**SPECIFIC REQUIREMENT'S (Section- Project)**  
C/ENGG/SPEC/SEC-PROJECT/SPECIFIC REQUIREMENT REV NO 06

Employer has standardized its Specific Requirement for various equipment and works for different voltage levels. Items or clauses, which are not applicable for the scope of this package as per schedule of quantities described in BPS or as per scope defined elsewhere in Section Project, the technical specification/clauses for the items specified below should not be referred to.

DRAWING NO. C/ENGG/SS/CONCEPTUAL 765KV BAY CONNECTIONS

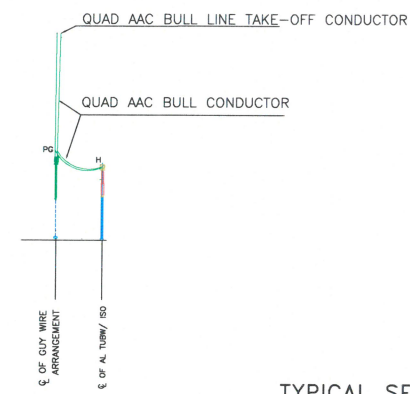
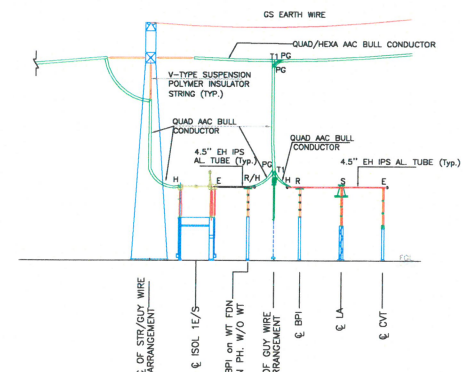
66.	<b>Section Switchyard Erection Rev 10</b>  <b>New Clause No. 21</b>	Connection arrangement of 765kV equipment's shall be done as per the conceptual drawing (Drawing No. C/ENGG/SS/CONCEPTUAL 765KV BAY CONNECTIONS, Rev-01) enclosed as Annexure-S1of this Section.
